# Ventura County Community College District

DATE: April 30, 2024  
TO: All Bidders  
FROM: David Cienfuegos, Purchasing Specialist  
SUBJECT: Addendum 1 – Bid 670, Oxnard College LA-7 Classroom Renovation

**OXNARD COLLEGE STEM CLASSROOM ALTERATION**  
4000 S ROSE AVE. OXNARD, CA 93033  
**ROOF PLAN & SECTIONS**

**2 PROPOSED FLOOR PLAN**

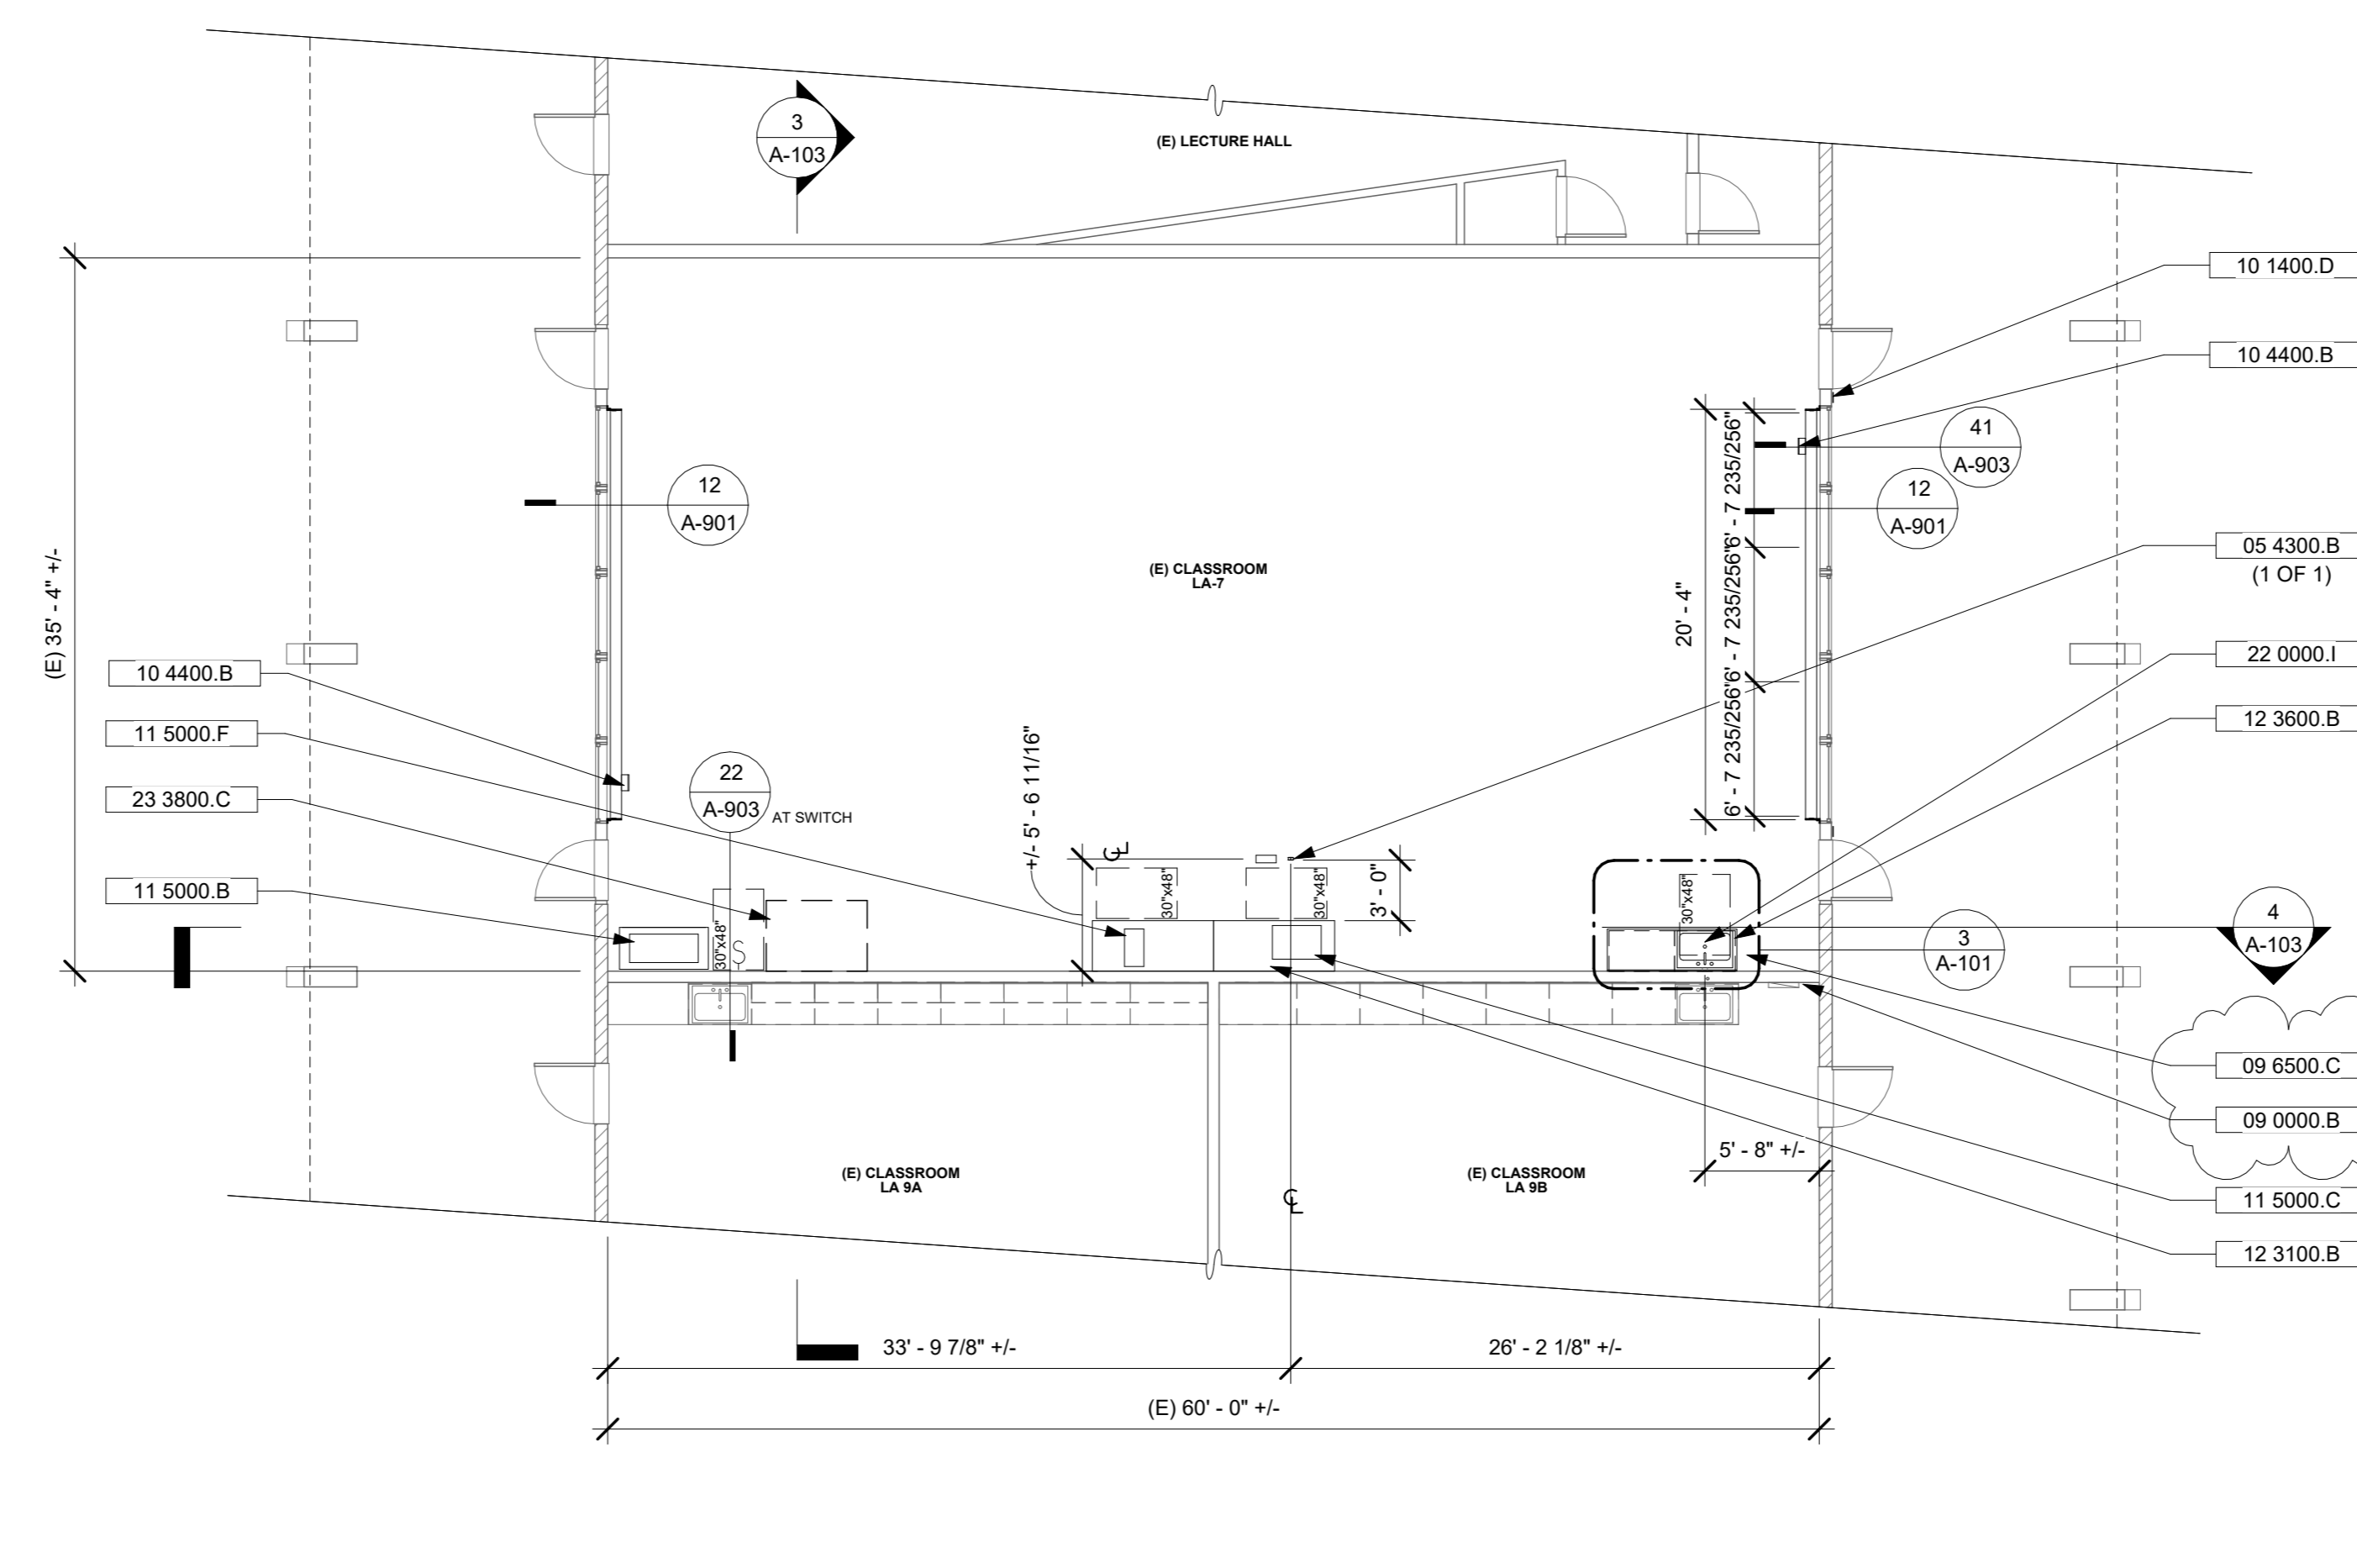
- A. Added keynotes to Drawing 2/Proposed Floor Plan

**5 HOOD SUPPORT PLAN**

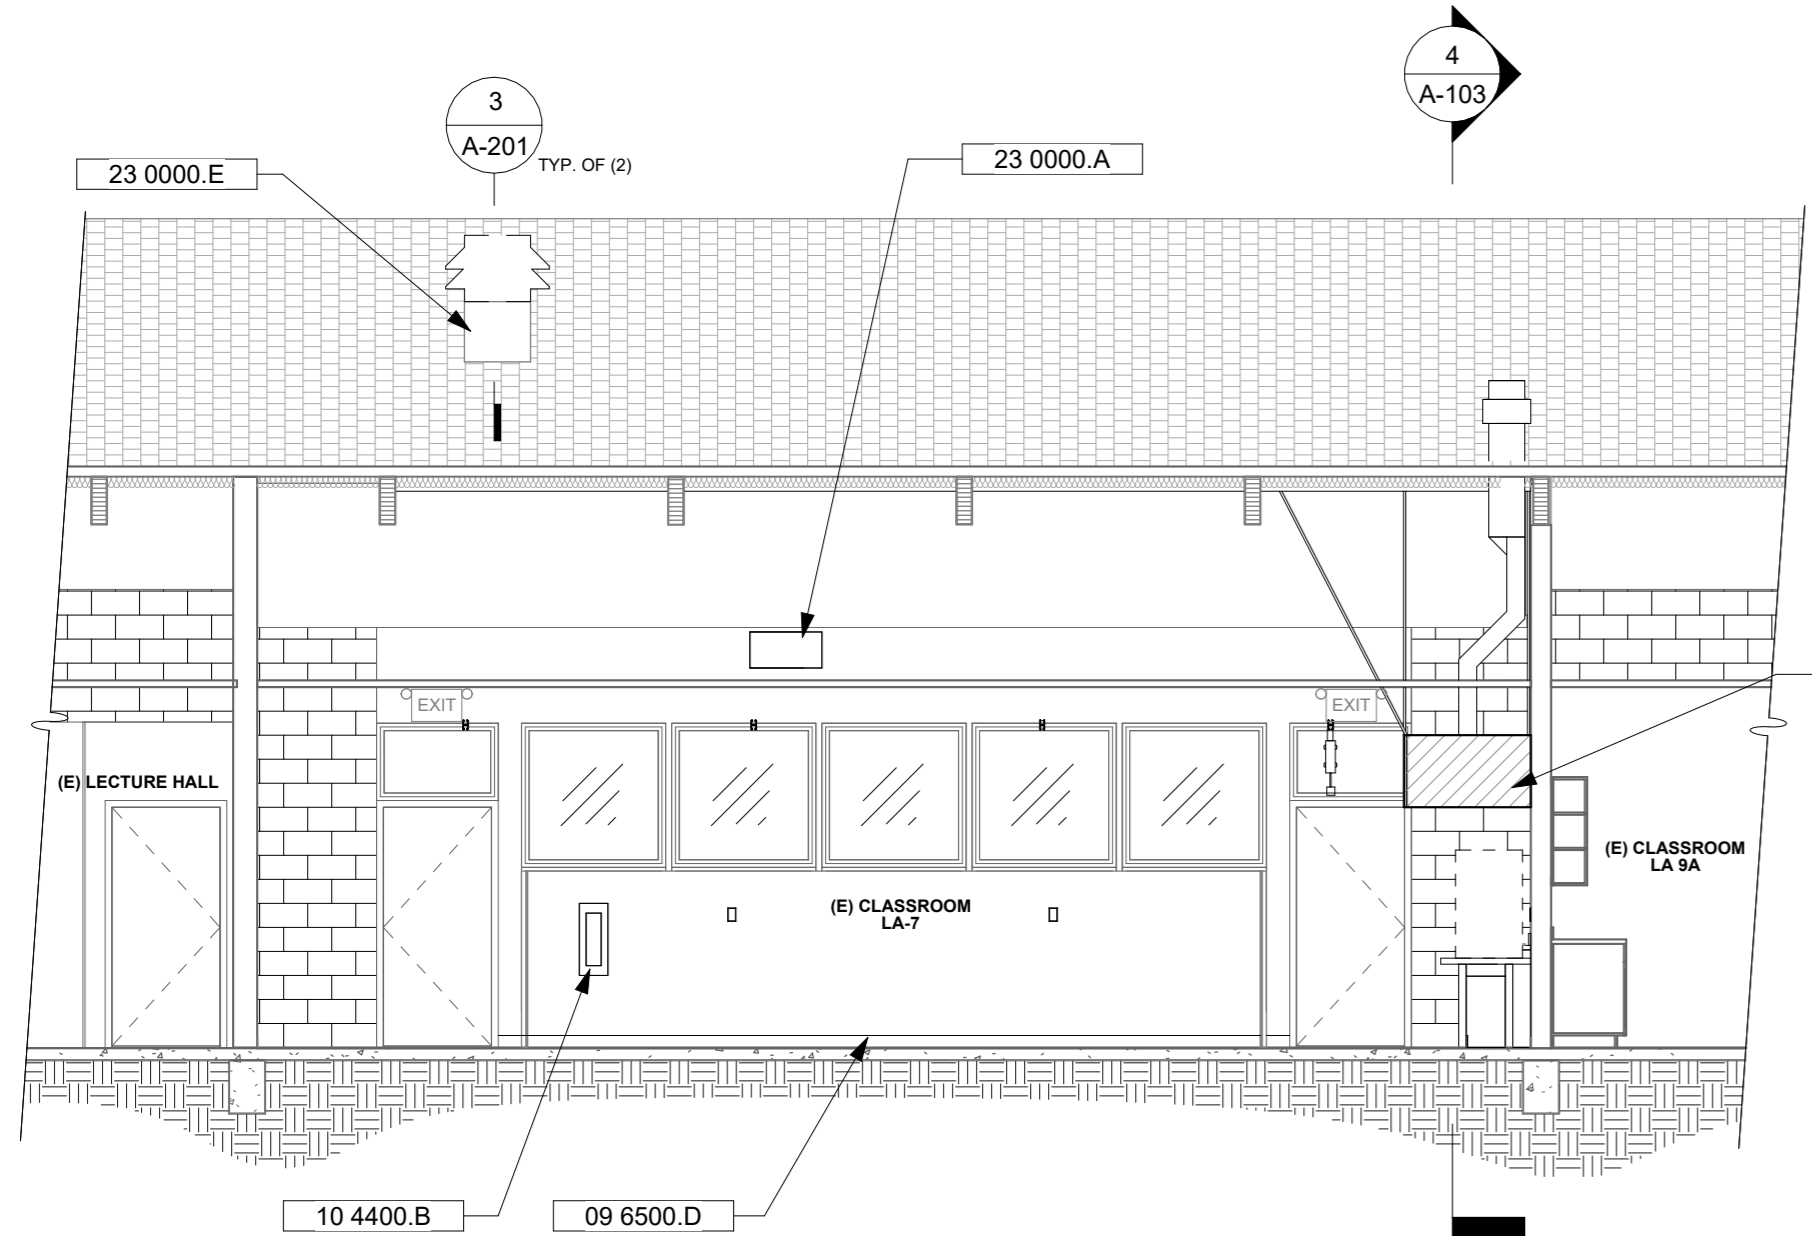
- A. Added notes and references to Drawing 4/Hood Support Plan and Drawing 5/Section B.
- B. Added keynote to Drawing 5/Section B
- C. Changed line type on Roof Plan Legend for clarity
